EARTHSCAPE HORTICULTURAL SERVICES
Arboricultural, Horticultural and Landscape Consultants
ABN 36 082 126 027

Addendum to Arborists Report
UTS Central – Section 96 Modification Application

I refer to the above matter your request to review the Section 96 Modification Application in relation to the UTS Central Project. I also refer to the previous Arboricultural Impact Assessment Report prepared by Earthscape (Version 5, dated 29th April 2016) submitted with the Development Application (DA) [State Significant Development 7382] and approved by the NSW Department of Planning and Environment on 23/09/2016.

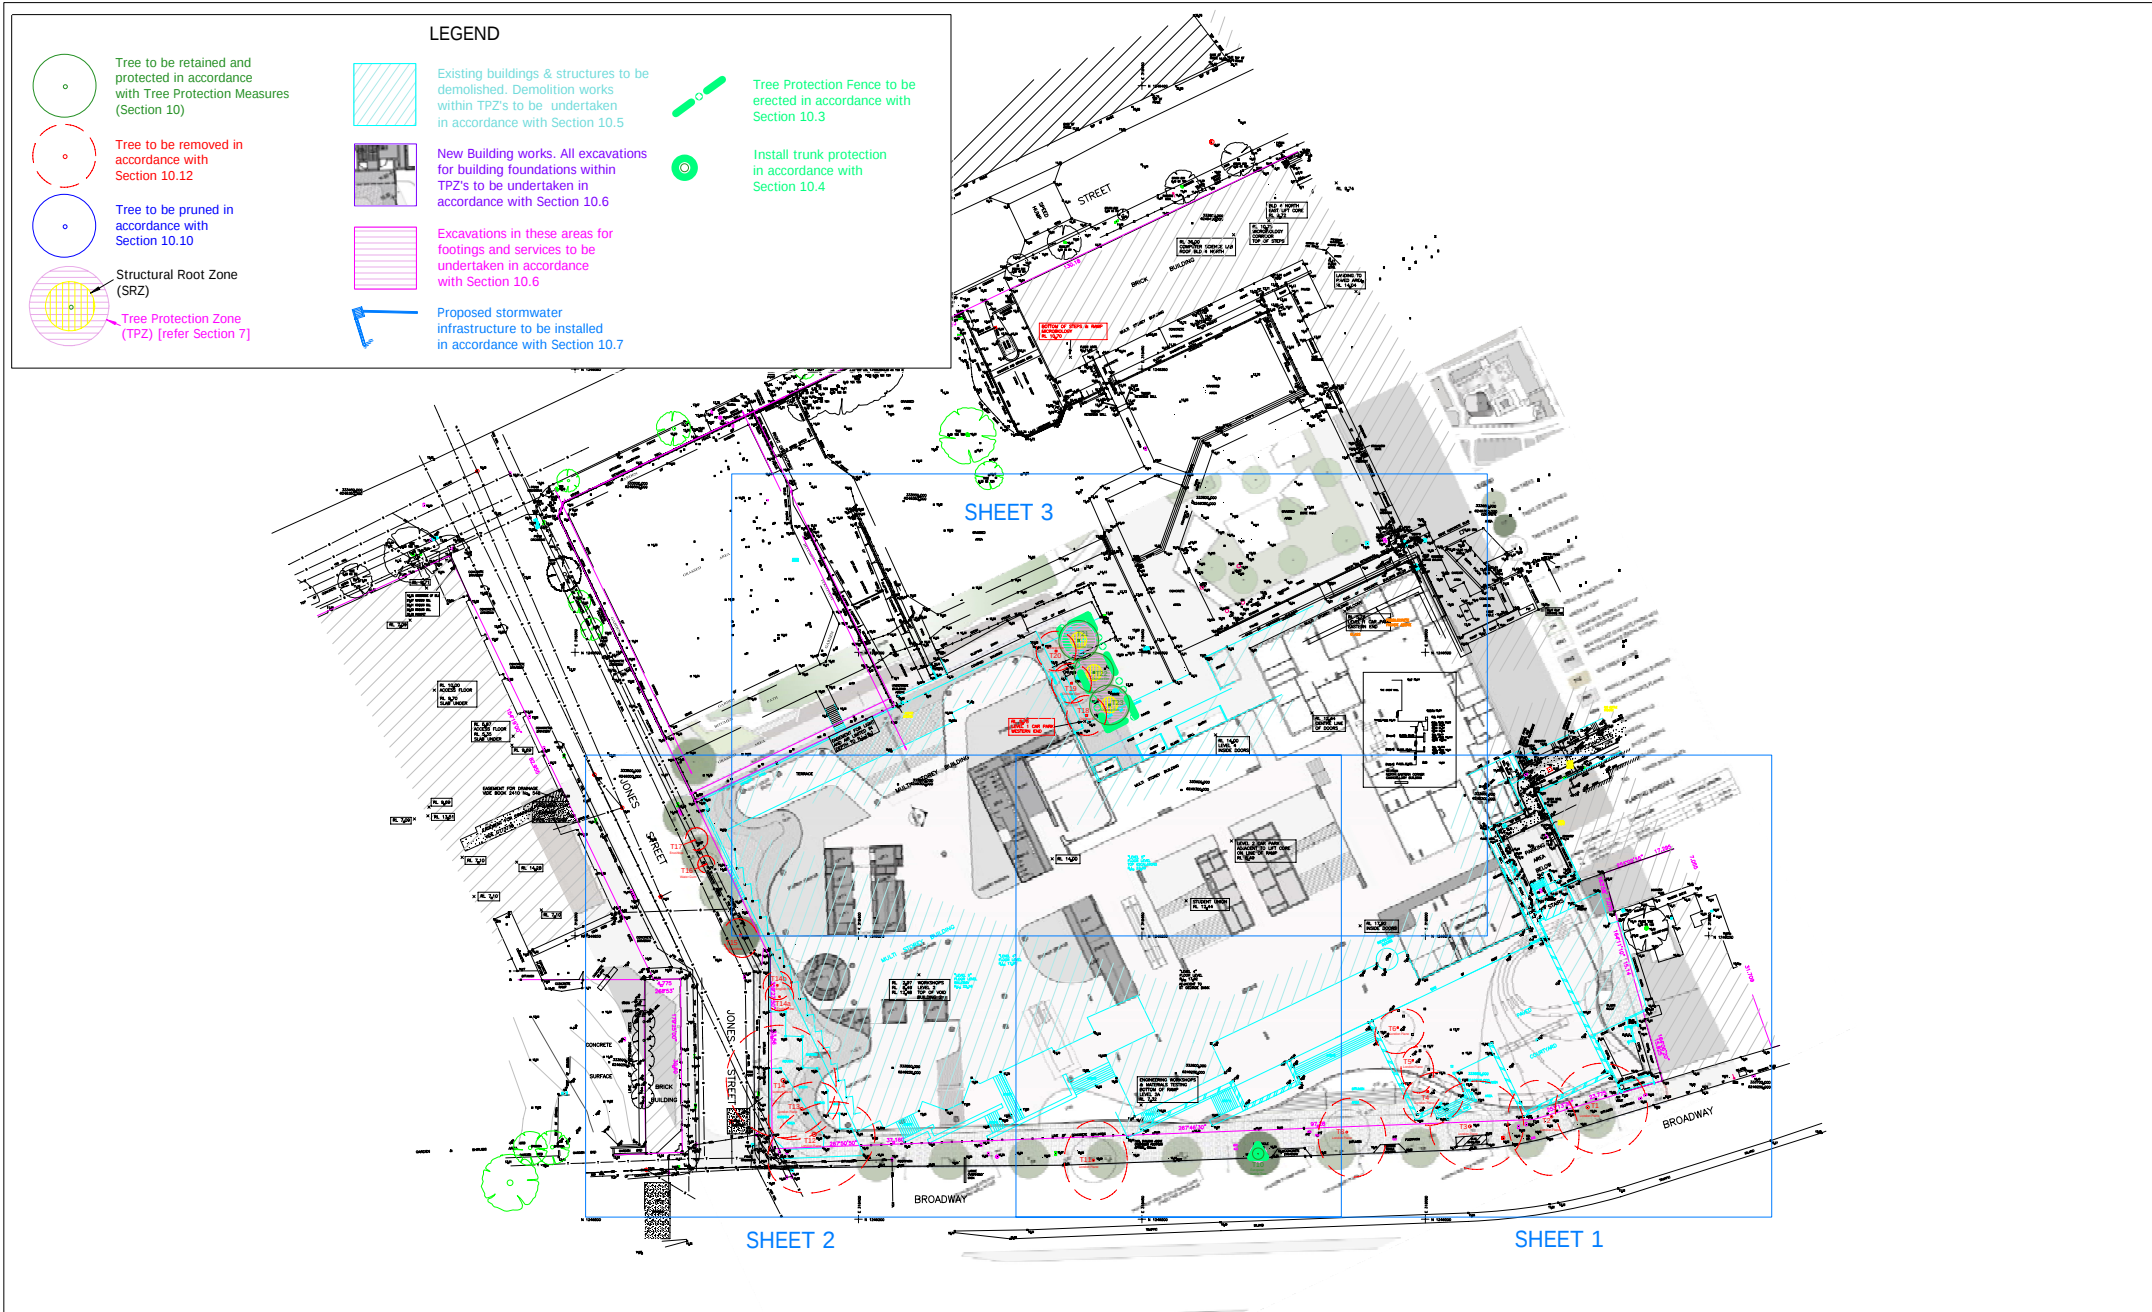
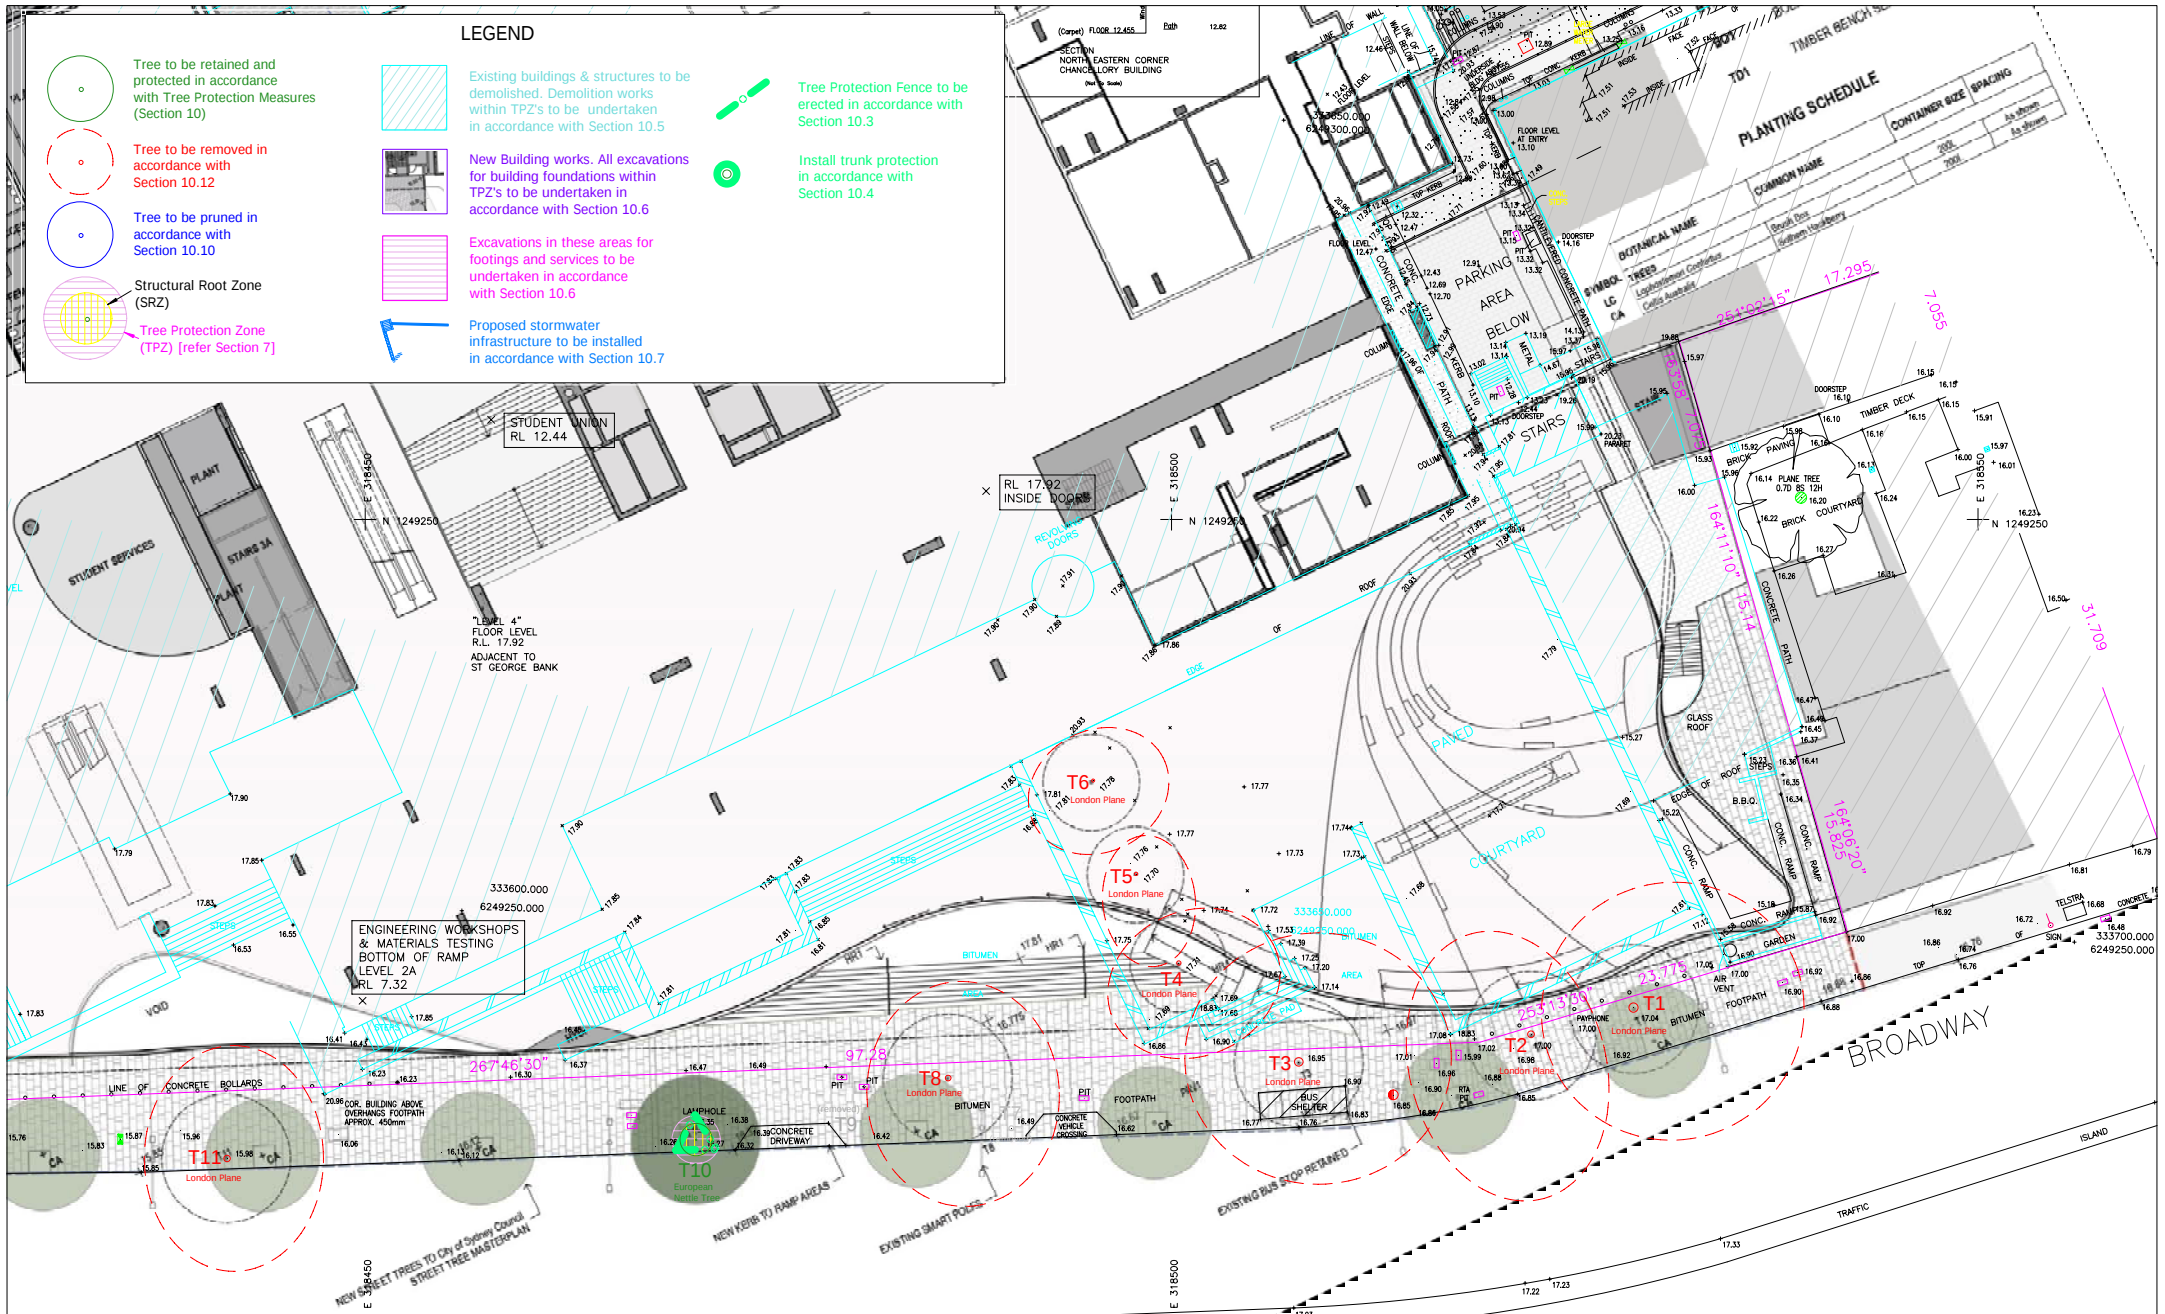
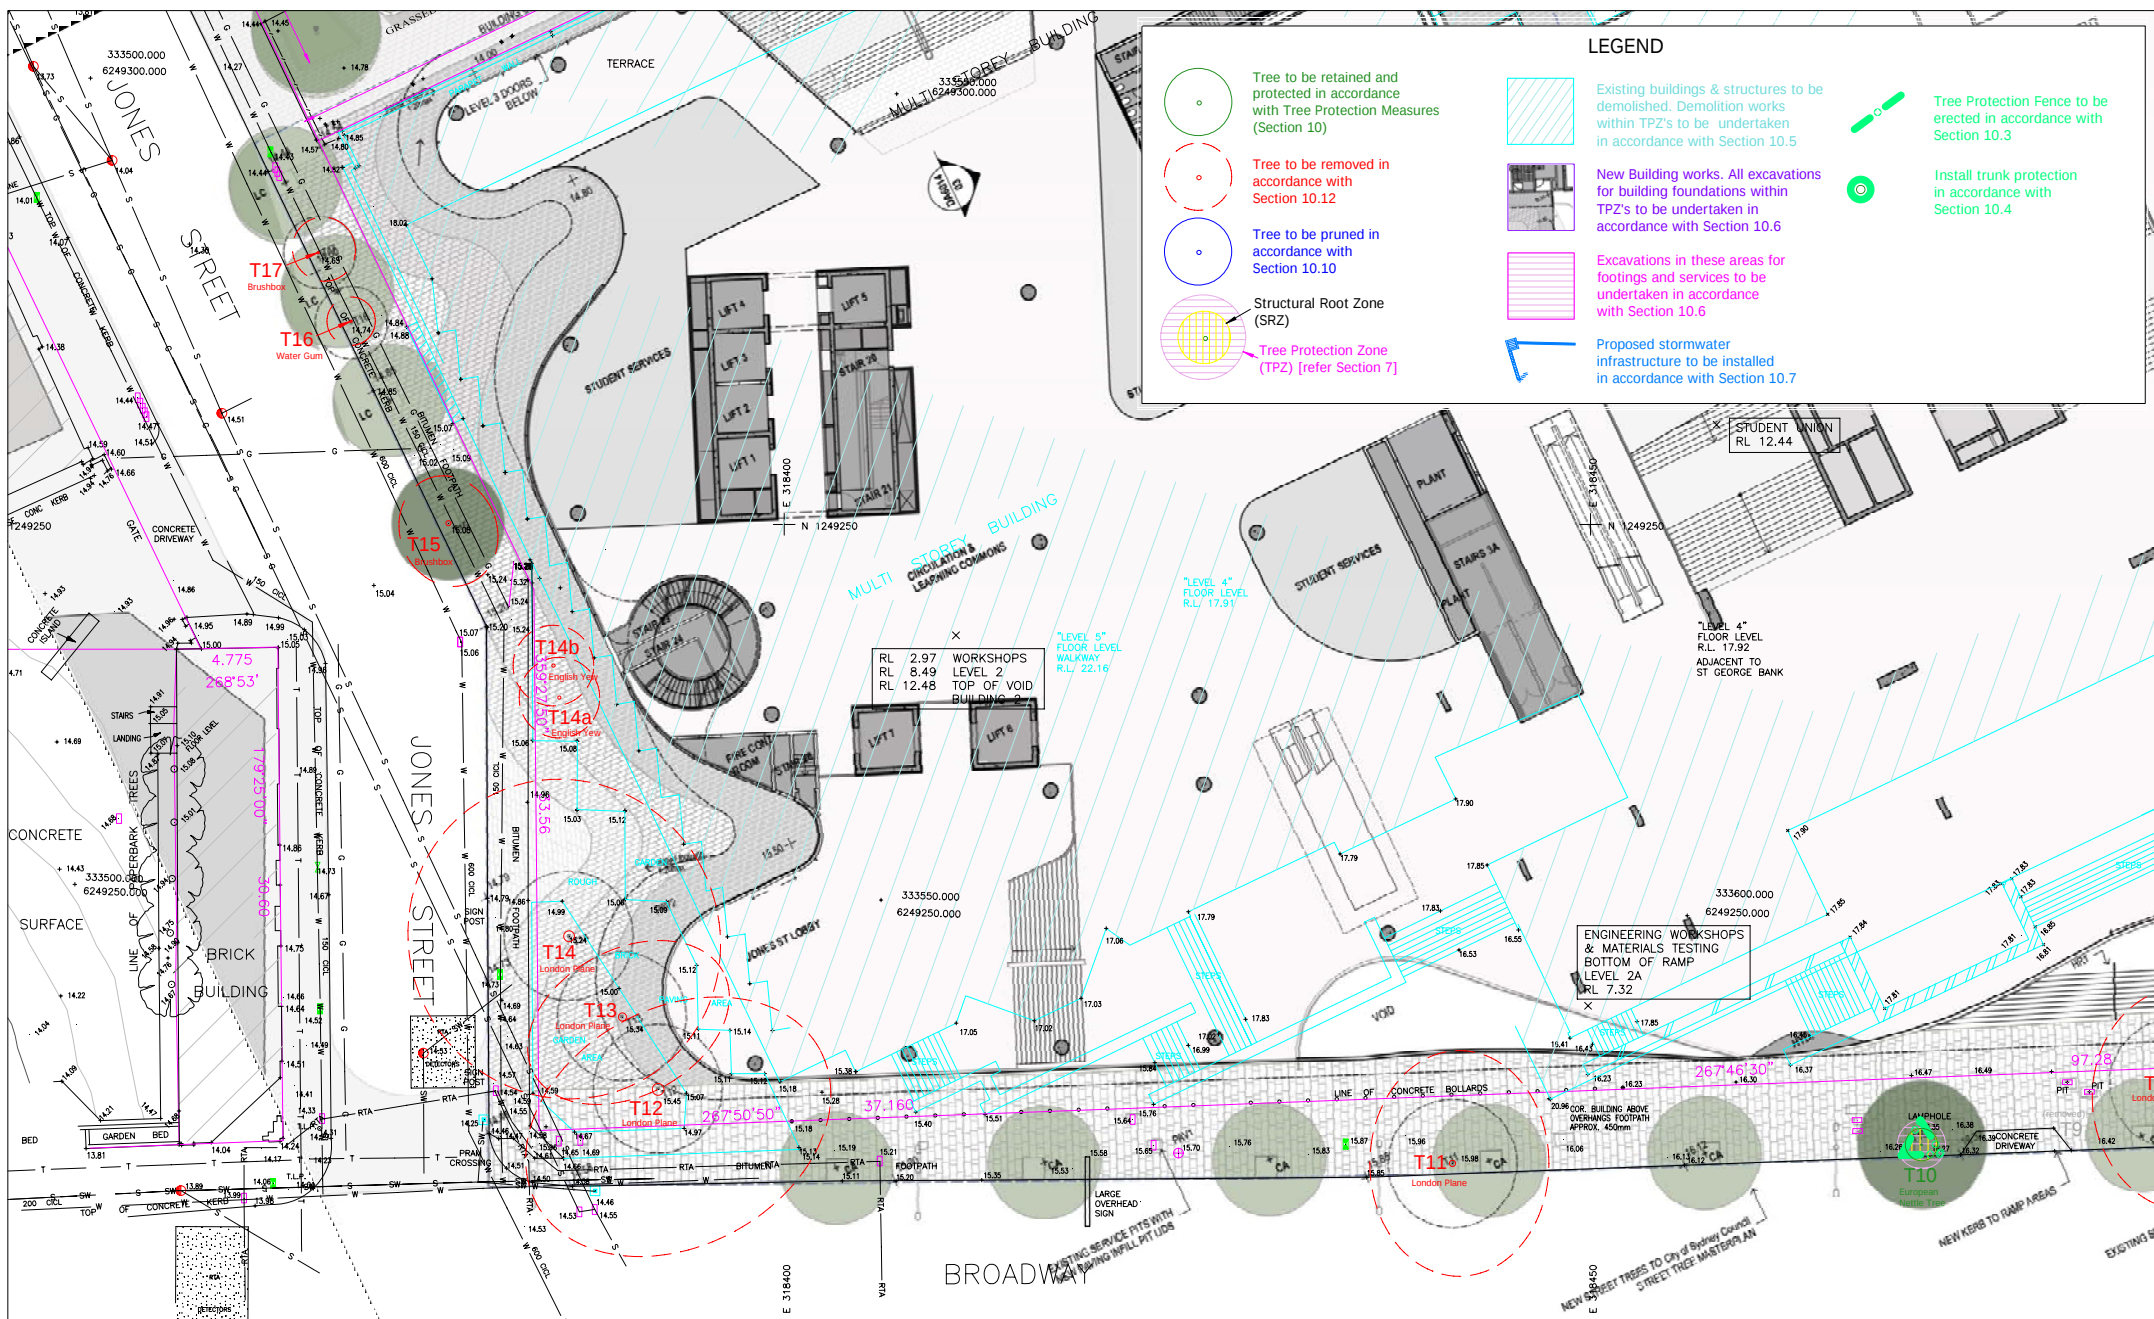
It is understood that proposed modifications to the design will now necessitate the removal of T15, a *Lophostemon confertus* (Bushbox) located on the nature strip in Jones Street adjoining the site. This tree was indicated for retention on the DA drawing and the above-mentioned report. The subject tree was classified as Moderate Retention Value. The subject tree is not considered significant, but is in good health and condition and makes a fair contribution to the amenity of the streetscape. The removal of this tree is now required to accommodate proposed modifications to the Jones Street façade of the building and landscape works along Jones Street.

The removal of the subject tree is considered warranted subject to replacement planting with a new tree in an appropriate position elsewhere on the nature strip as part of the Jones Street landscape works in accordance with Section 11 of the abovementioned report. A revised Tree Protection Plan (Appendix 6) and Impact Assessment Schedule (Appendix 4) are attached.
